Project No. 2035-099

Subject: Gross Reservoir Hydroelectric Project, FERC Project No. 2035. Denver Water's response to FERC's February 1, 2017 letter requesting additional information on its License Amendment Application filed on November 25, 2016.

## **ADDENDUM TO RECREATION MANAGEMENT PLAN (ARTICLE 416)**

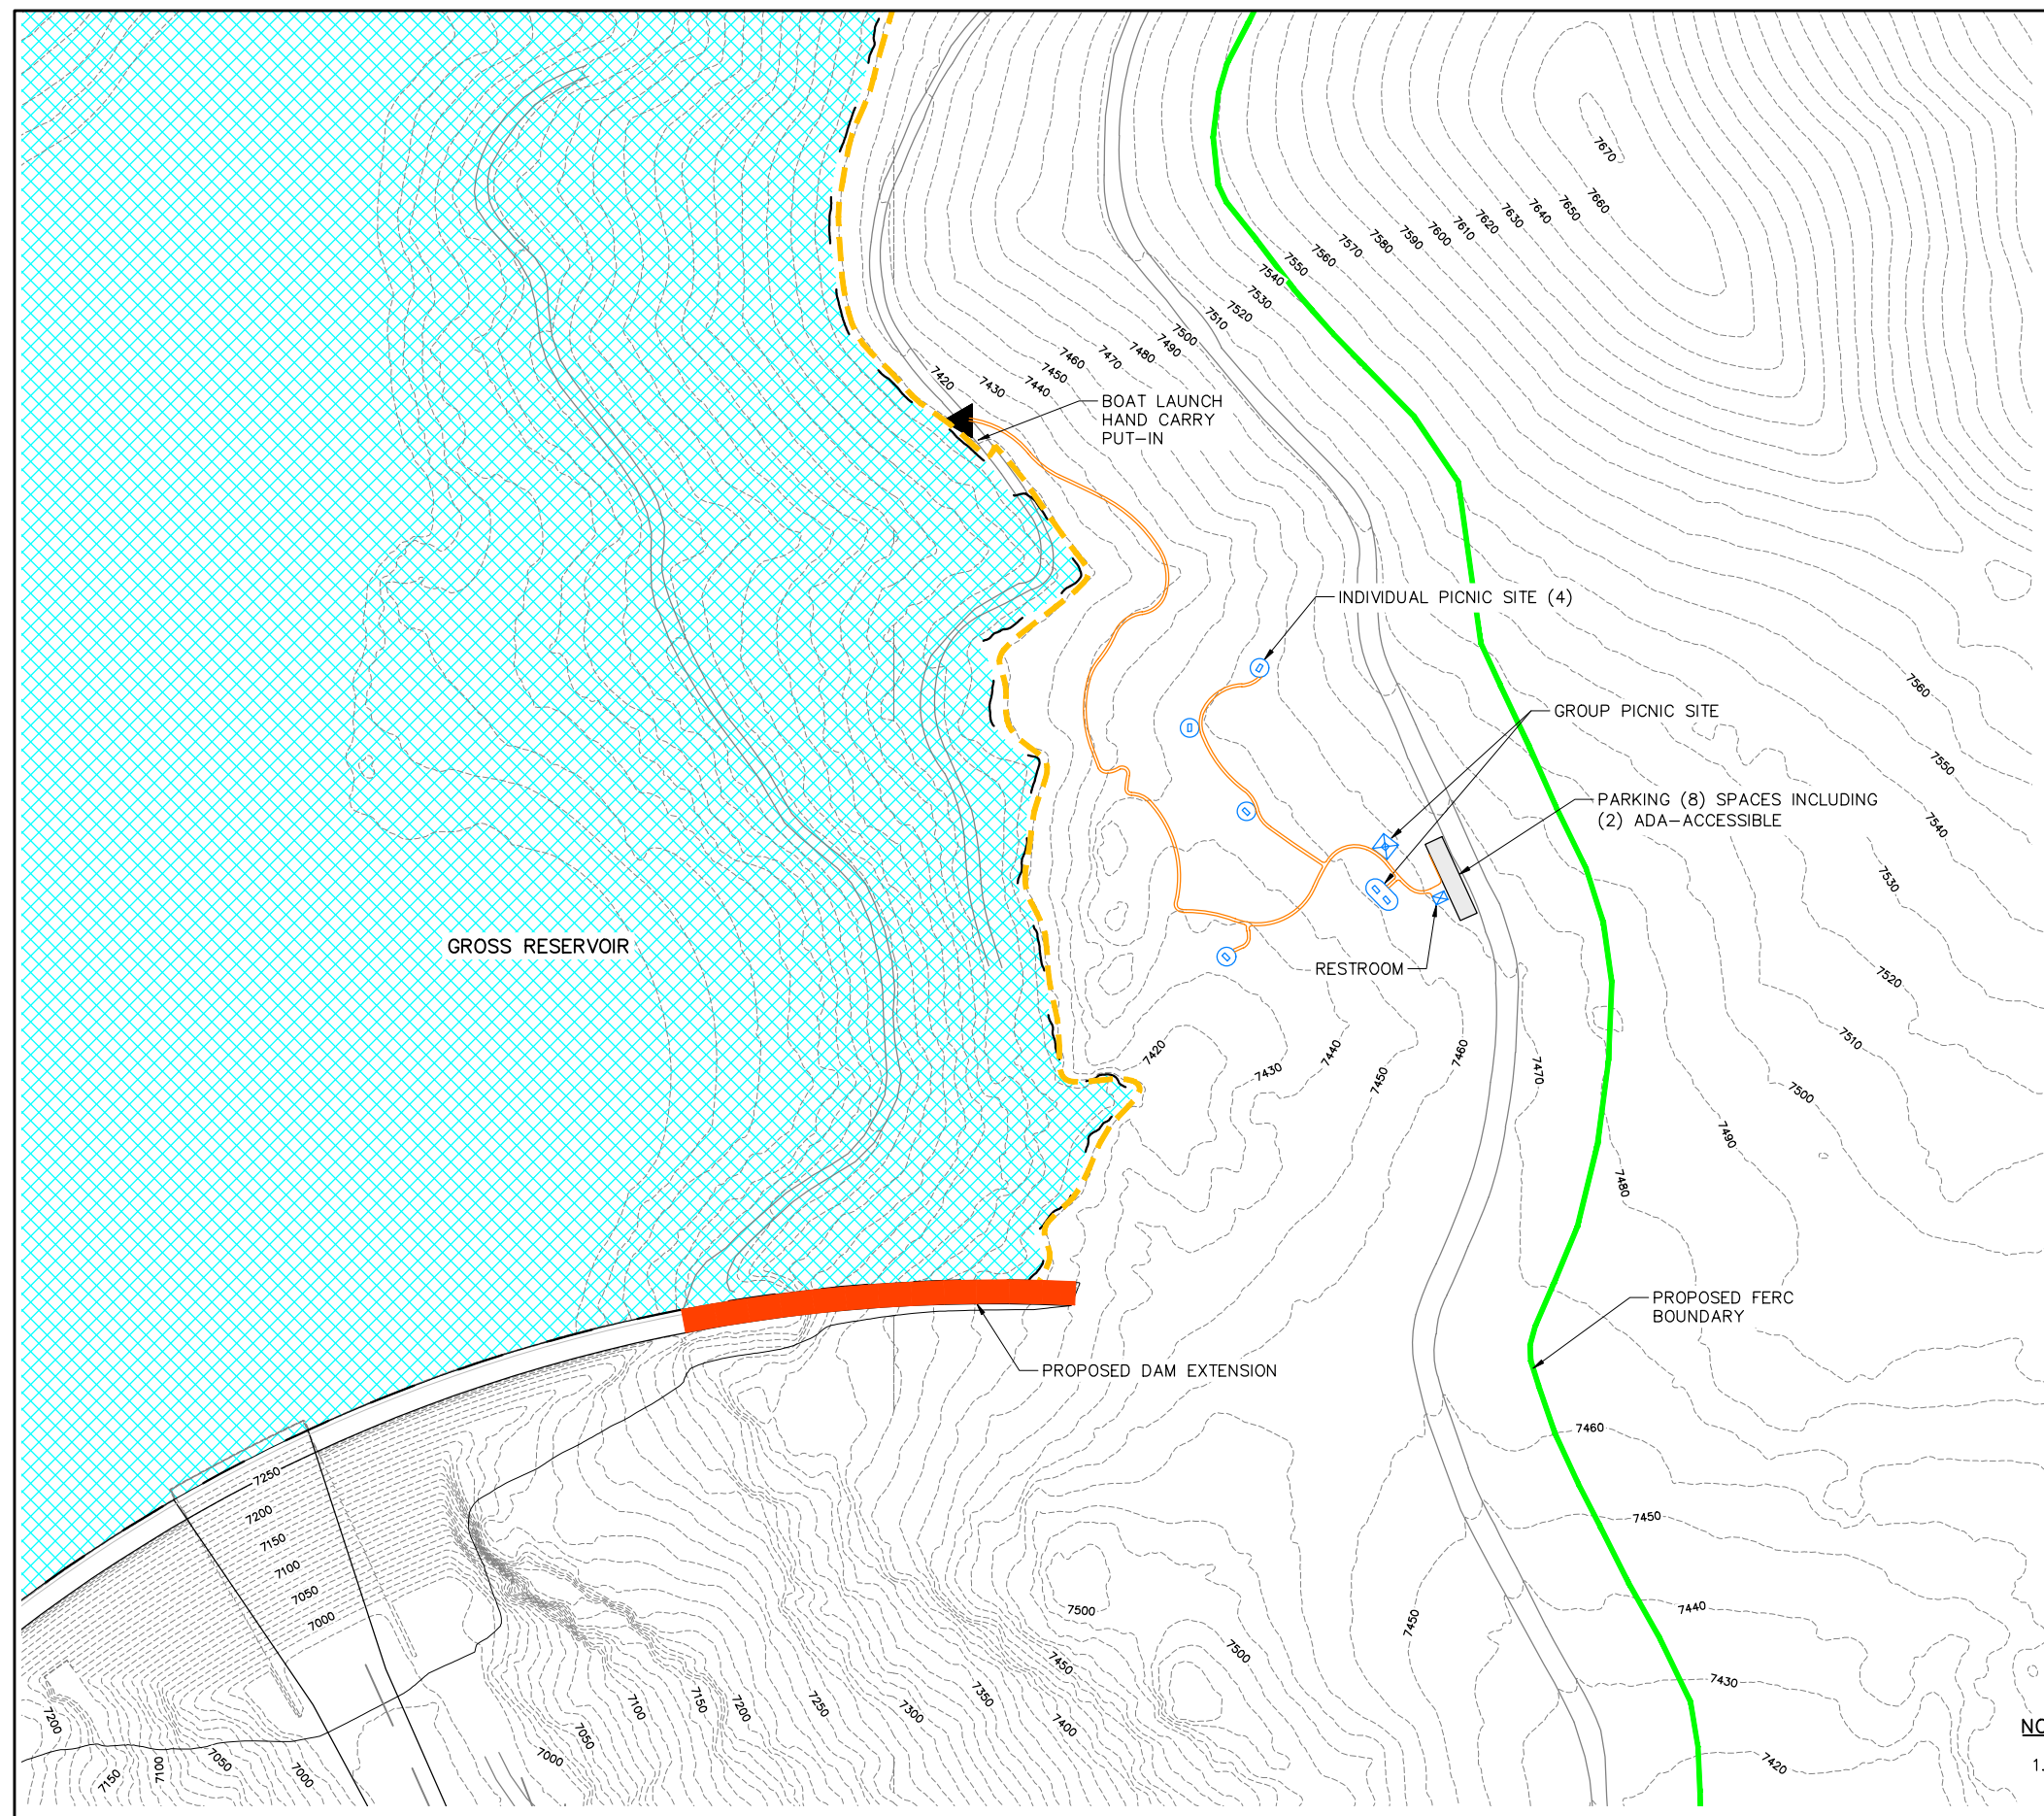
4. **Boat launch and overlook at Peninsula Recreation Area. Exhibit E and as-built drawings filed August 30, 2016, indicate a hand boat launch is present at the Peninsula Recreation Area. The recreation plan addendum does not account for its inundation and relocation. Please clarify if you propose to relocate this boat launch in the recreation plan addendum. Also, the table in the recreation plan addendum (p. 4) lists one overlook at the Peninsula Recreation Area; this is not included in Table 3.3.15-1 in your Exhibit E or reflected on as-built drawings filed August 30, 2016. Please clarify which overlook the addendum is referring to.**

The Recreation Management Plan (RMP) Addendum has been updated to reflect the hand boat launch site that would be relocated from the Peninsula Recreation Area to the Northern Dam Viewpoint Area, as shown in the revised RMP Addendum Figure L2 and revised table “Existing Facilities to be Relocated” on page 4 of the RMP Addendum (see **Attachment 2**).
